Service Bulletin No: 53-014

ATA Chapter: 53

FUSELAGE - GENERAL**DO A CHECK OF THE MATERIAL SPECIFICATION USED IN THE MANUFACTURE OF THE ENGINE MOUNT FITTINGS AND, IF NECESSARY, DO A CHECK FOR CRACKS WITH A BOROSCOPE****1. Planning Information****A. Effectivity**

Check of the Material Specification
Figure 1

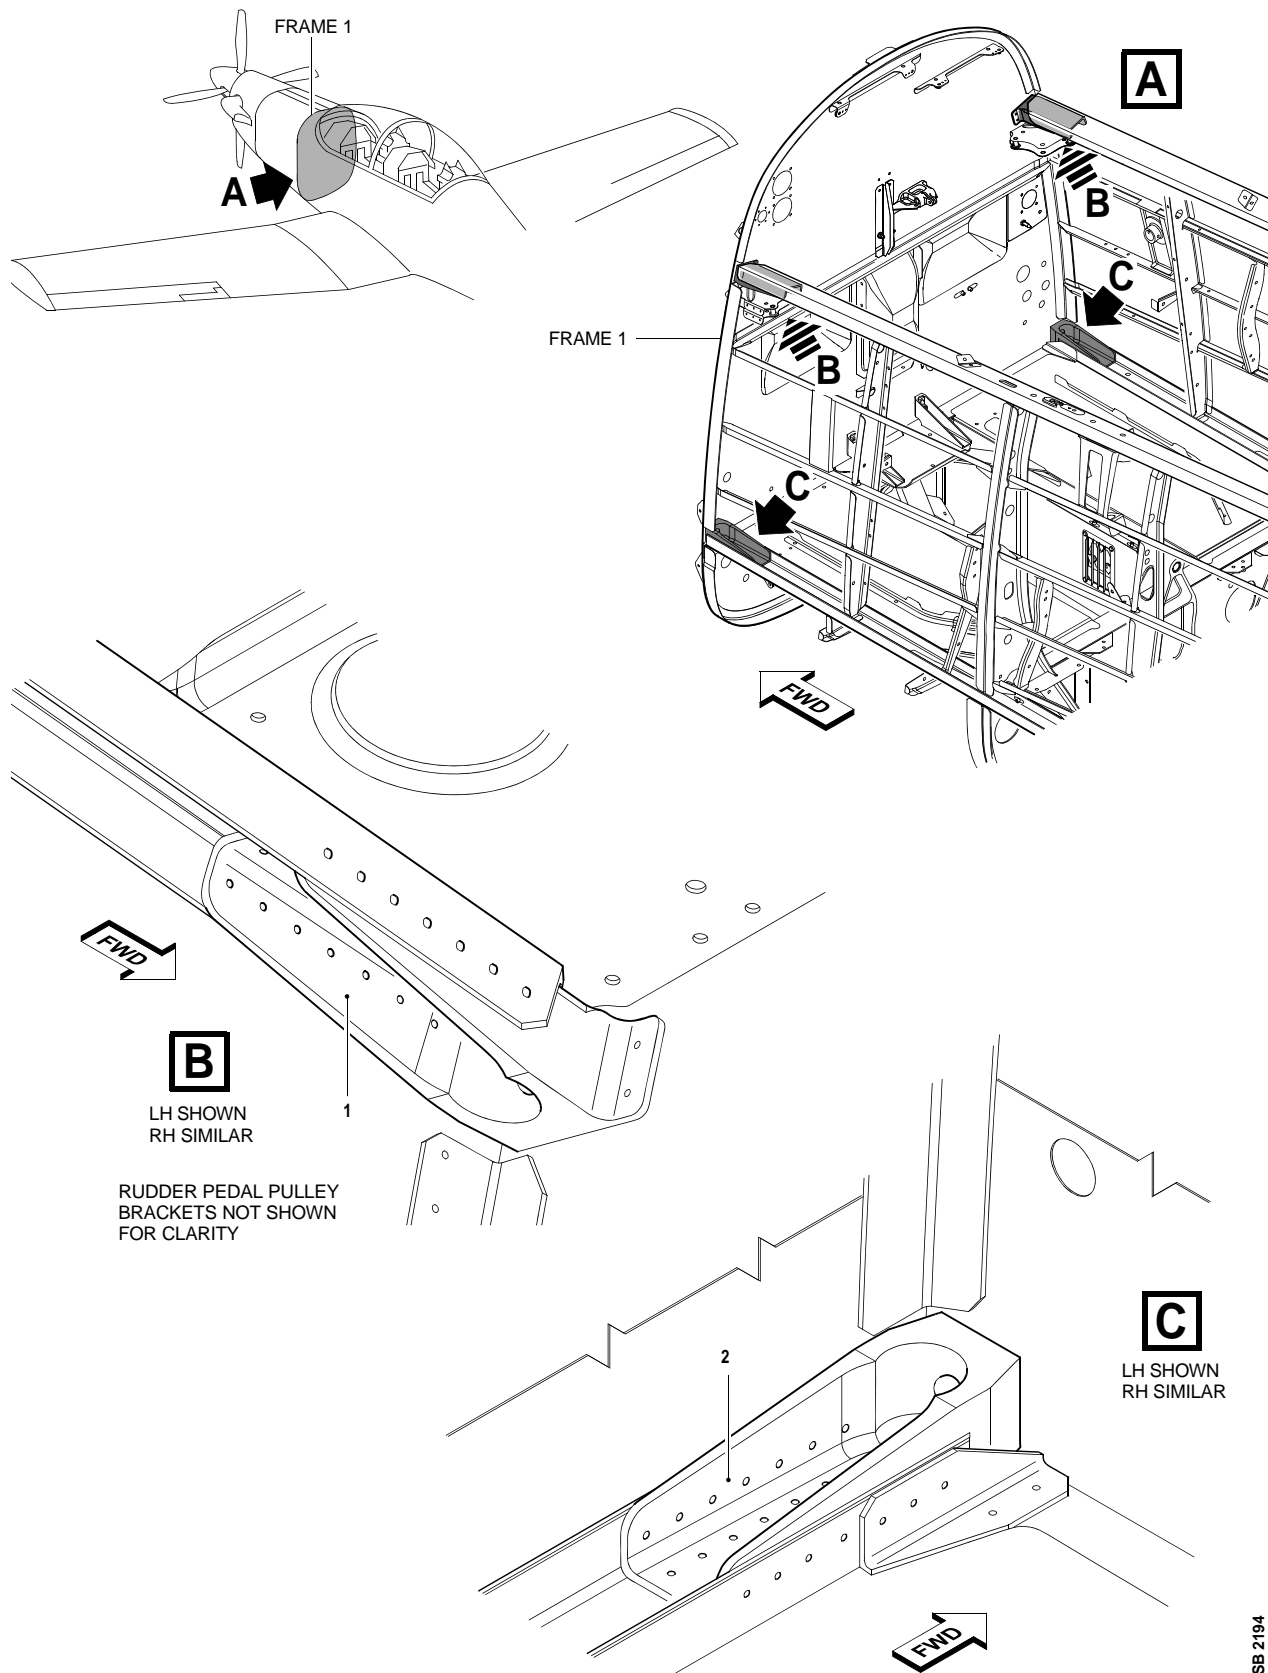
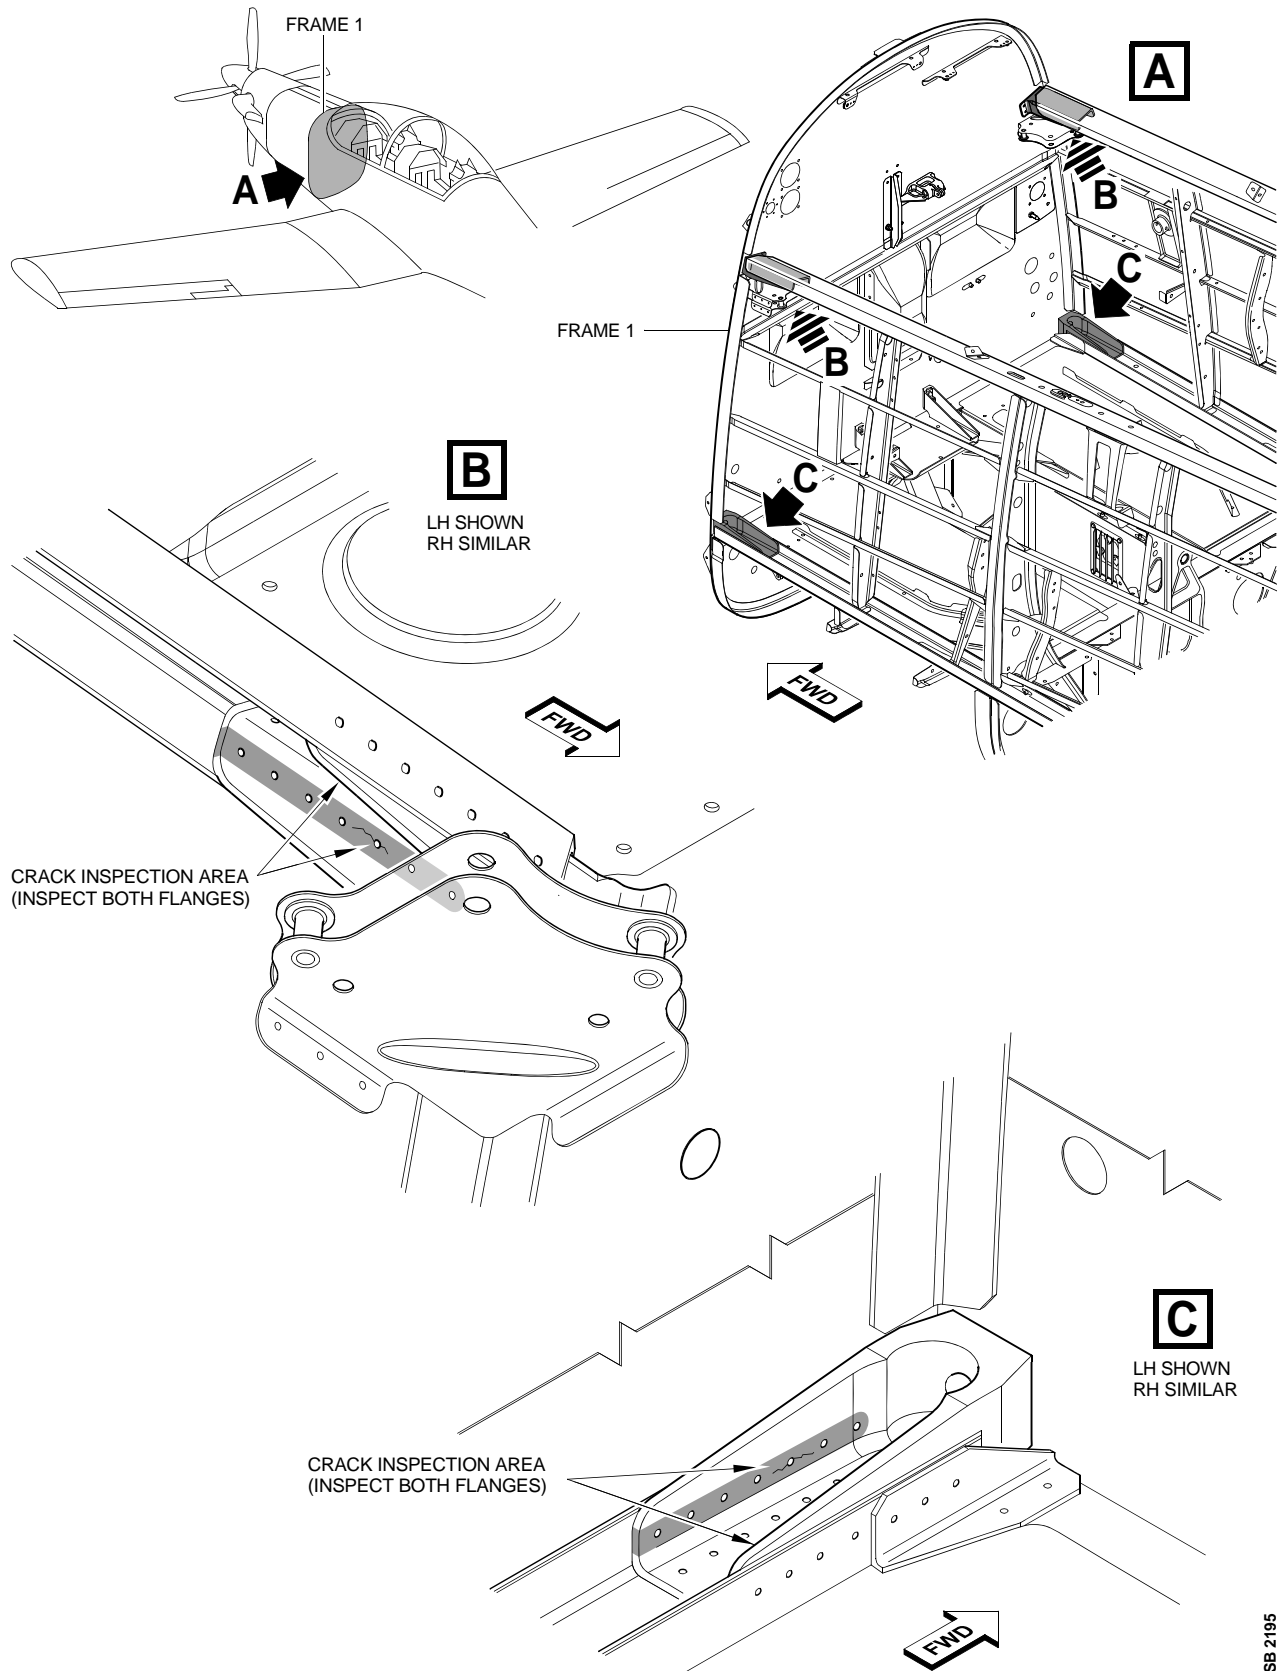
B. Do the Test to Find the Material Specification (Ref. Fig. 1)

- (1) For the left upper engine-mount attachment-fitting (1) (P/N 553.10.09.123):

- (b) Put the eddy current probe in position on the left upper engine-mount attachment-fitting (1) (P/N 553.10.09.123).
 - (c) Record the value shown on the test equipment.

- (d) Compare the value recorded above with the values recorded in Section 3.A.(5) and determine if the attachment fitting is manufactured from AA2024-T351 or AA2124-T851.

- (e) Do Steps 3.B(1)(b) thru (d) again to make sure the result is the same.
 - (f) Write the type of material that the left upper engine-mount attachment-fitting (1) (P/N 553.10.09.123) is made from on the Status of Parts Form (Ref. Fig 5).

Fittings - Crack Inspection (If Necessary)
Figure 2

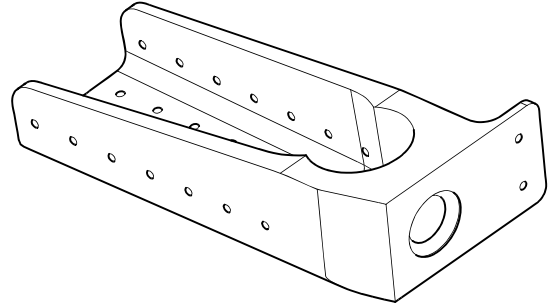
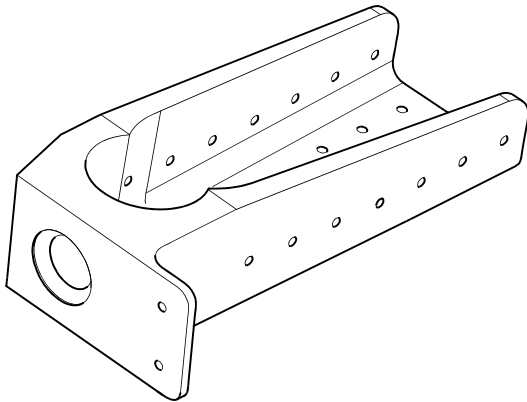
C. Do the Boroscope Inspection to Find Cracks (Ref. Fig. 2)

- (1) Obey the manufacturer's instructions and use a boroscope to examine the areas shown in Fig. 2:
- (a) Use the aluminium or steel tube as a guide for the boroscope to access the inspection areas.
 - (b) If you find cracks:
 - 1 You must contact Pilatus Customer Support before next flight. The address is:
